Re: Bay State Gas Company, D.T.E. 05-27

RESPONSE OF BAY STATE GAS COMPANY TO THE
FIRST SET OF INFORMATION REQUESTS FROM THE D.T.E.
D. T. E. 05-27

RESPONSE OF BAY STATE GAS COMPANY TO THE
THIRD SET OF INFORMATION REQUESTS FROM THE D.T.E.
D. T. E. 05-27

BAY STATE GAS COMPANY - ALL DIVISIONS UNPROTECTED STEEL MAINS AND CORROSION LEAKS

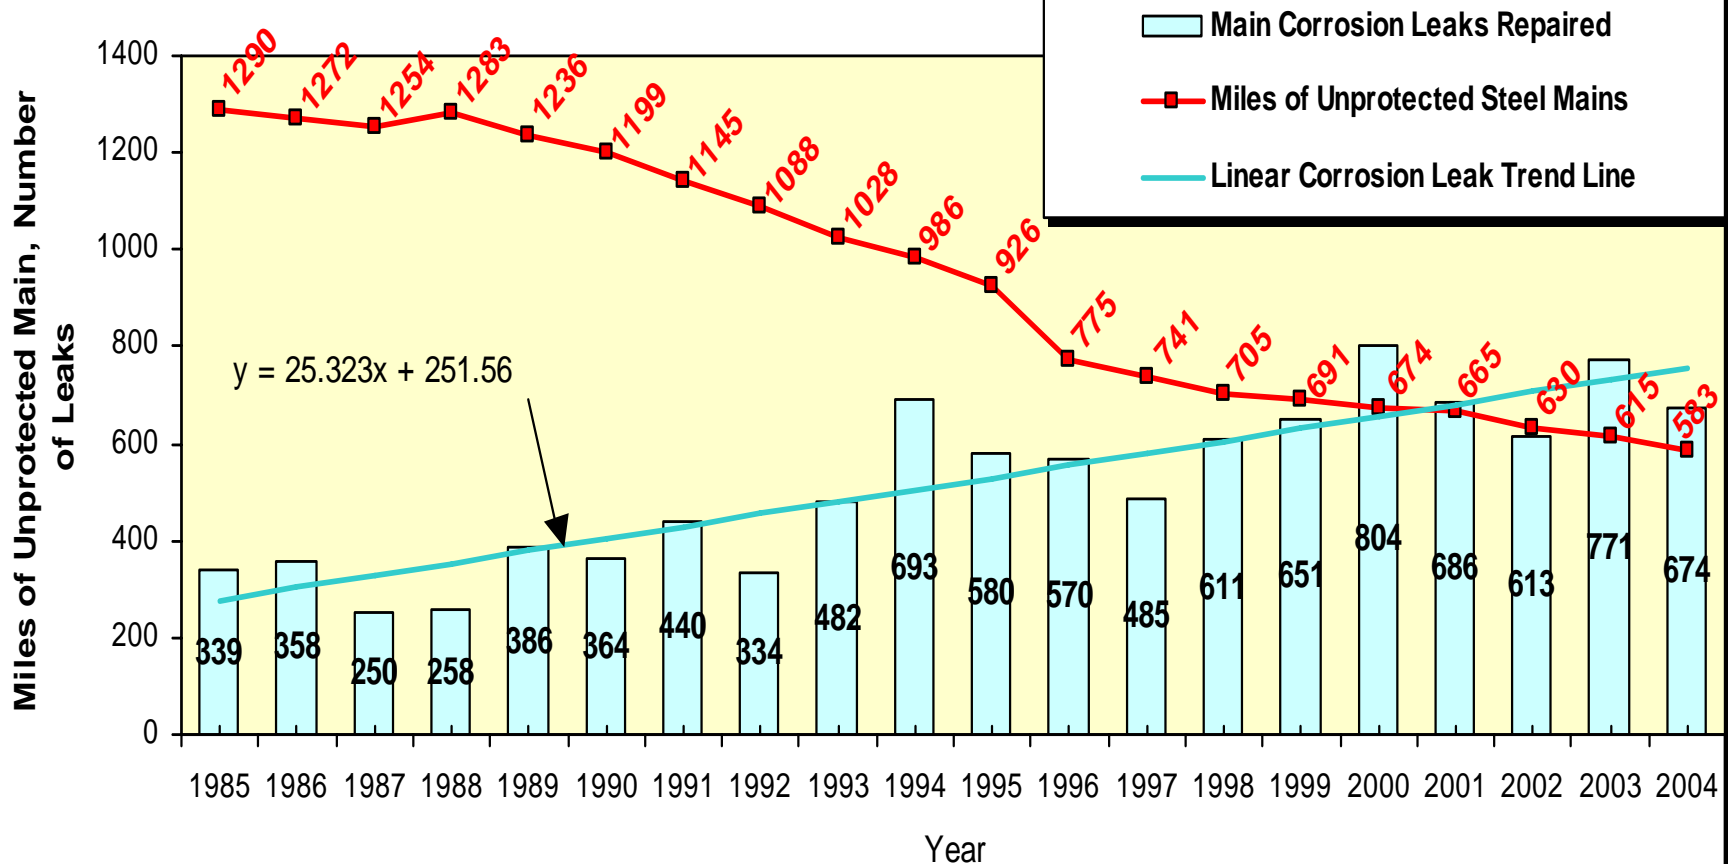
DTE-3-6 Refer to Exh. BSG/DGC-1, at 16. Please provide any studies, reports and memoranda relied upon by the Company to support its conclusion that Bay State's recent corrosion leak rate per year is three times the leak rate of 17 years ago.

Response: Please see Attachment DTE-3-6 for two graphs that illustrate: (1) 20 years worth of Company-wide system corrosion leak rates on unprotected steel mains compared to total miles of unprotected steel mains; and (2) 20 years worth of Company-wide system corrosion leak rates per mile on unprotected steel mains compared to total miles of unprotected steel mains.¹

For example, the data on Page 1 of Attachment DTE-3-6 demonstrates that Bay State had 250 corrosion leaks in 1987 compared to 771 corrosion leaks in 2003, which constitutes a 3-fold increase in leaks during that period. This increase in the absolute number of leaks occurred while at the same time the total amount of unprotected steel mains declined through replacement by approximately 50%, from a total amount of 1254 miles of unprotected main in 1987 to 615 miles in 2003.

Further, the data on Page 2 of Attachment DTE-3-6 demonstrates that on a leaks-per-mile basis the corrosion leak rate in the Bay State system has escalated by a factor of 6, going from 0.2 leaks per mile in 1987 to 1.25 leaks per mile in 2003.

In sum, both the absolute number of leaks and the leaks per mile data demonstrate that the number of leaks on Bay State's remaining unprotected steel system is accelerating, and such data fully support the Company's proposal to implement a systematic and comprehensive Steel Infrastructure Replacement program.
